# Access Compliance Report

## Public Rights-of-Way

### (Curb Ramps)

Intersection ID: 10035338	Main Street: RAIL_CROSSING_LN	Cross Street: N/A	Location: NE
ADA ID: A3A8591EBE23	Ramp Type: Perp	Initial Pass/Fail: Fail	Overall Compliance: No
Severity Score: 13.75			
Codes/Mitigation Info/Possible Solution		Field Measurements/Component Compliance

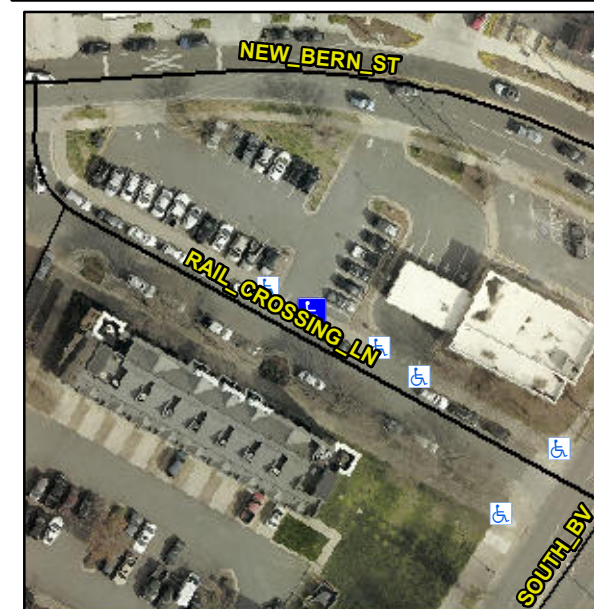
**Not Found, R304.2.2**

Compliance	Description	Data	Compliance	Description	Data
N/A	Ramp Length (in)	63.0	No	Ramp Slope (%)	9.3
Yes	Ramp Width (in)	63.0	Yes	Ramp XSlope (%)	5.0
N/A	Flare Type LT	N/A	N/A	Flare Type RT	N/A
N/A	Flare Slope LT (%)	N/A	N/A	Flare Slope RT (%)	N/A
N/A	Flare Traversable LT?	N/A	N/A	Flare Traversable RT?	N/A
N/A	Landing Length (in)	N/A	N/A	DWS Provided?	N/A
N/A	Landing Width (in)	N/A	N/A	DWS Contrast?	N/A
N/A	Landing Slope (%)	N/A	N/A	DWS Length (in)	N/A
N/A	Landing X Slope (%)	N/A	N/A	DWS Full Width?	N/A
N/A	Landing Curb? (Y/N)	N/A	N/A	DWS Offset (in)	N/A
N/A	Shared Landing?	N/A			
N/A	Gutter Ponding?	N/A	N/A	Gutter Slope (%)	N/A
N/A	Gutter Lip Ht (in)	N/A	N/A	Gutter X Slope (%)	N/A
N/A	Painted X Walk1?	No	N/A	Painted X Walk2?	N/A
	X Walk 1 Direction	To NW		X Walk 2 Direction	N/A
N/A	X Walk 1 Width (in)	N/A	N/A	X Walk 2 Width (in)	N/A
	X Walk 1 Slope (%)	2.4		X Walk 2 Slope (%)	N/A
	X Walk 1 X Slope (%)	5.0		X Walk 2 X Slope (%)	N/A

**Remove & Replace Entire Ramp.**
